New Monks Farm Sustainable Transport Issues

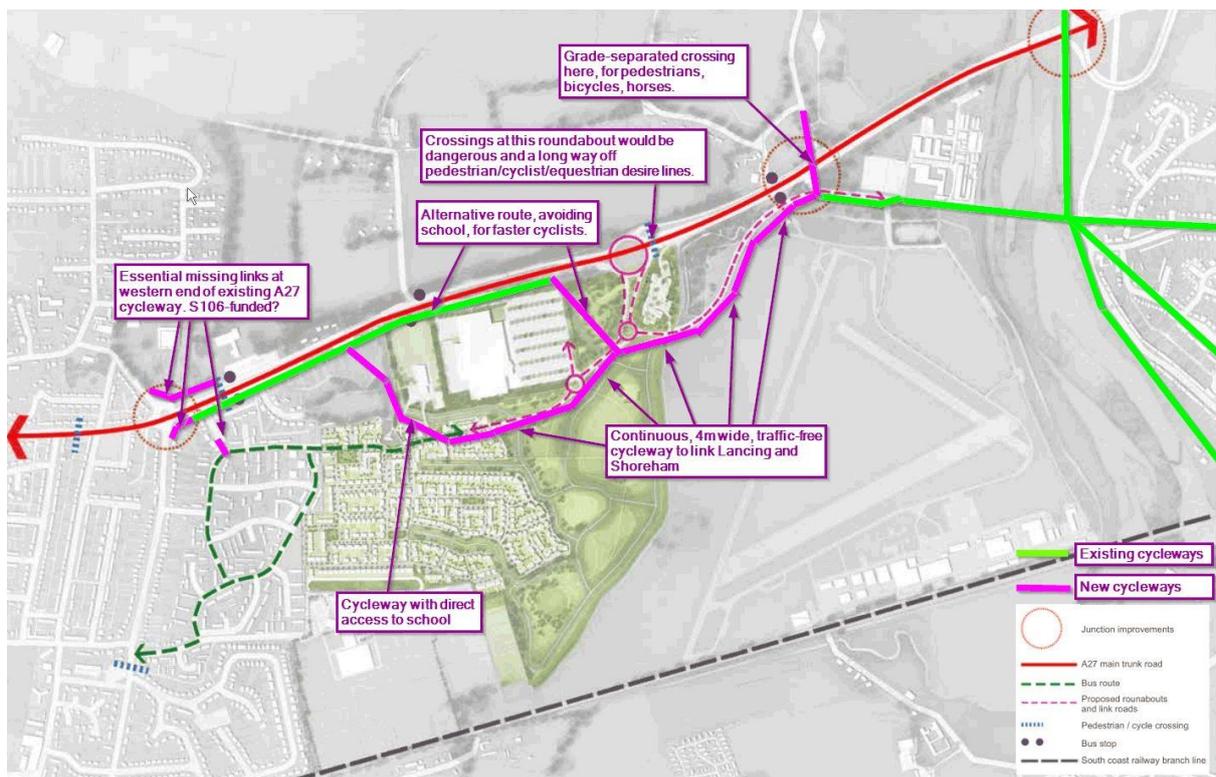
Road widths within site – 6.5m and 5.5m
